Appl. No. 10/801,492
Amdt. dated March 21, 2006
Reply to Office Action of February 6, 2006

Amendments to the Drawings

FIG. 3 A

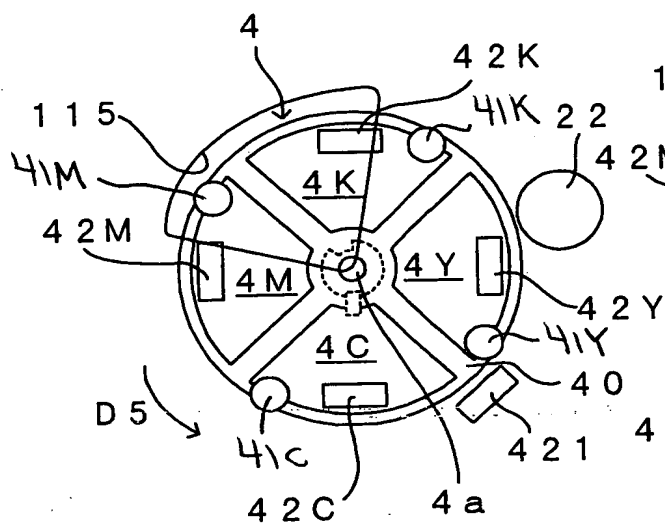
The attached sheet of drawings includes changes to Fig. 3A. This sheet, which includes Figs. 3A, 3B and 3C, replaces the original sheet including Figs. 3A, 3B and 3C. In Fig. 3A, previously omitted reference signs 41M, 41C, 41Y and 41K have been added.

The drawings are objected to under 37 CFR 1.84(p)(5) as not including reference sign 41 mentioned at page 15, line 14 of the specification. In response, the specification is amended to individually refer to developing rollers 41Y, 41C, 41M and 41K, and the group designation "41" is deleted. Fig. 3A is correspondingly amended to include reference signs 41Y, 41C, 41M and 41K to designate the developing rollers.
